MOCCASIN RD CCRFCFCD FLOOD CONTROL FACILITY MOCCASIN RD TO CCRFCFCD FACILITY LVUP 1076/1077

PREPARED BY	SLATER HANIFAN GROUP	DESIGNED BY	CM	DRAWN BY	BCC	CHECKED BY	FR
CITY OF LAS VEGAS	BID# 19-1033	DATE: JAN 2020	SUBMITTAL STAGE:	100% FINAL			
TITLE		MOCCASIN RD		GENERAL NOTES, KEY MAP AND SHEET INDEX			
SHEET		GN-2		3 OF 48			
DRAWING NO.		731-99

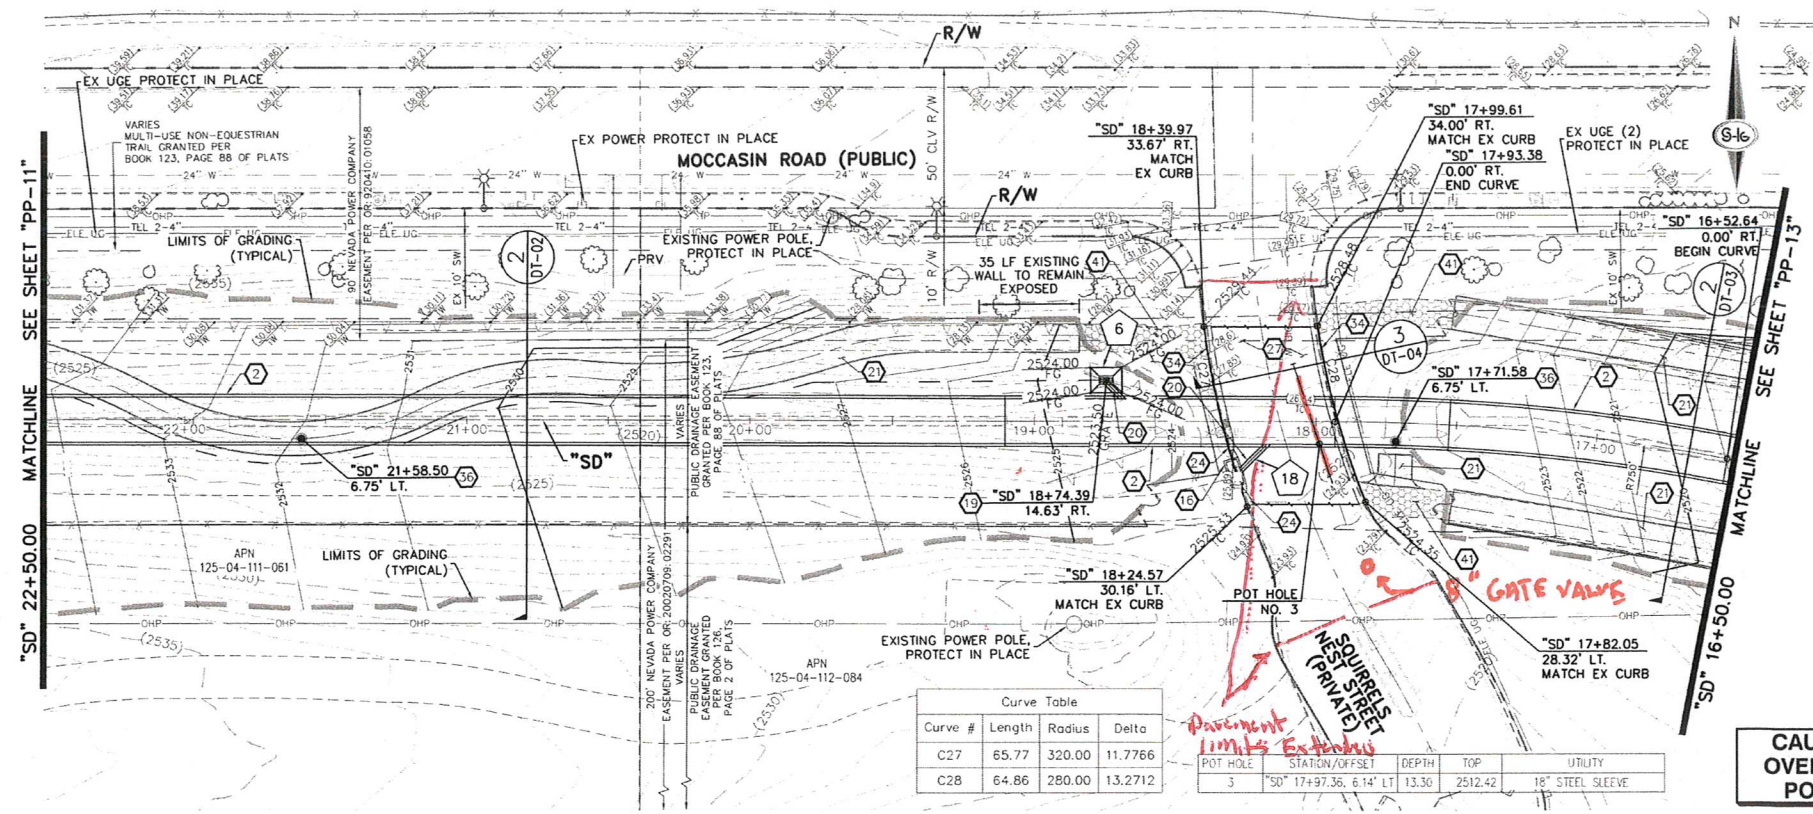
Response/Clarification:

The proposed solution is acceptable to the city. Please make sure these changes are reflected in the asbuilts.

MOCCASIN RD
CORFCD FLOOD CONTROL FACILITY
MOCCASIN RD TO CORFCD FACILITY LVUP 1076/1077
SHEET
PLAN AND PROFILE
"SD" 16+50.00 TO "SD" 22+50.00

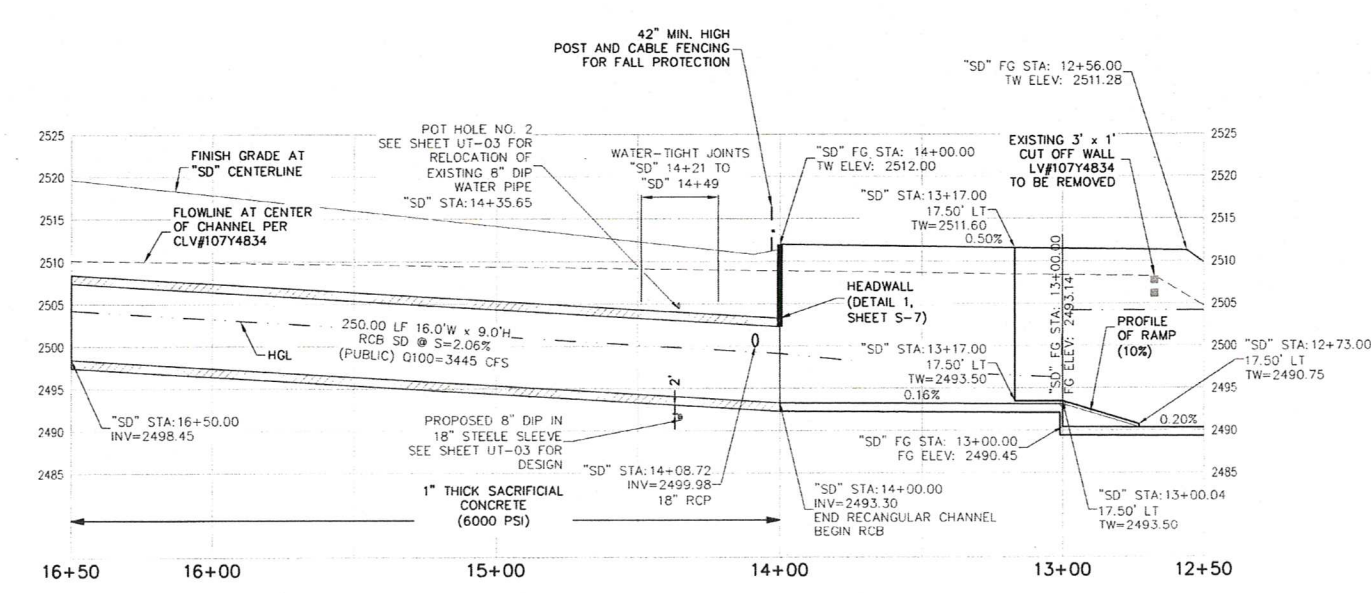
Added Riprap
25' grade

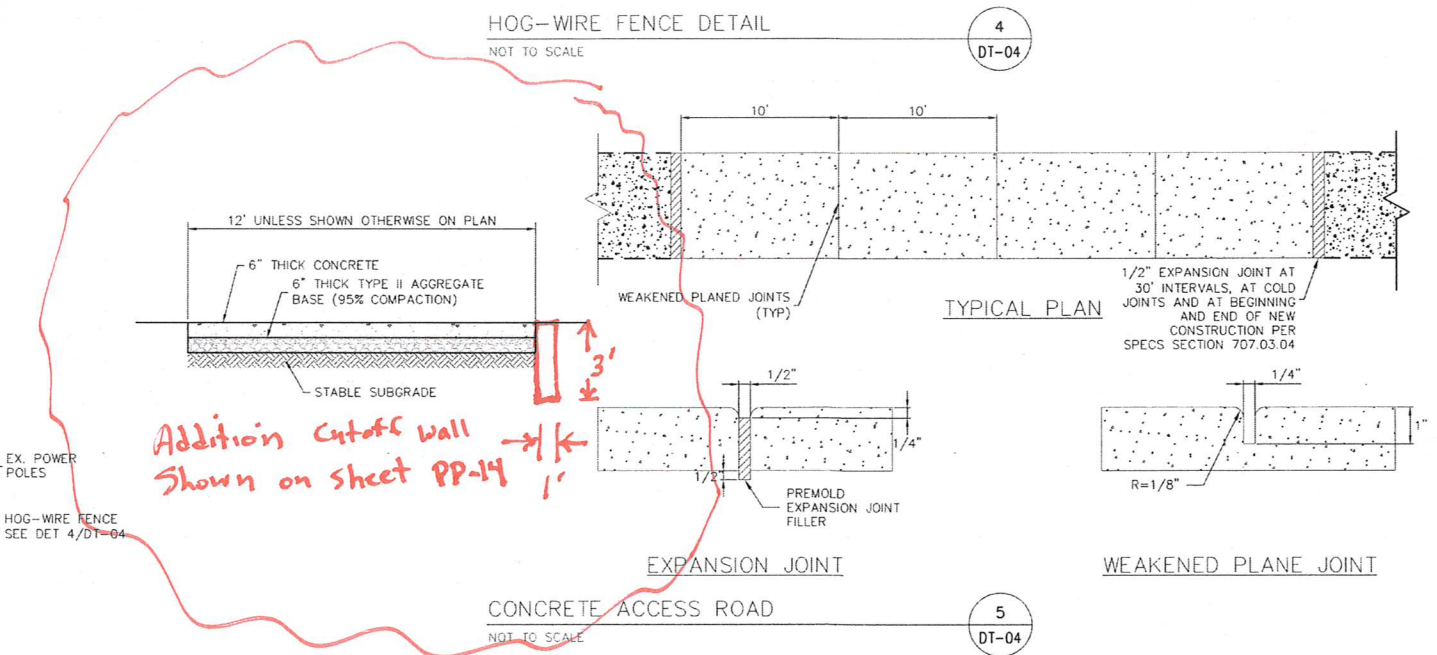
*Addition cutoff wall
Shown on sheet PP-14*

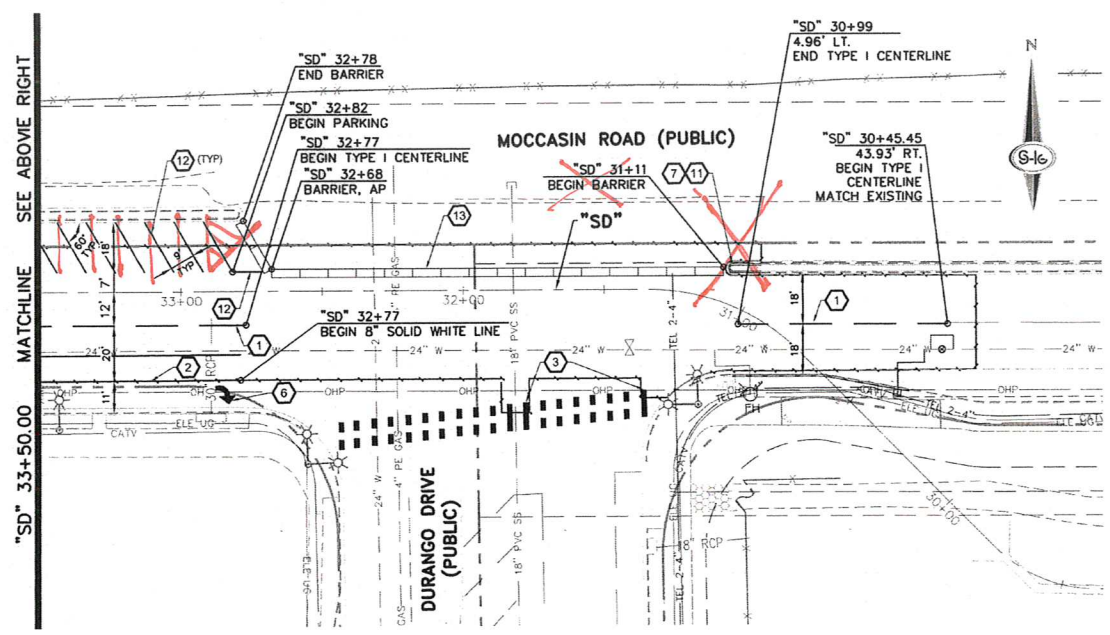
Changed to straight parking stall
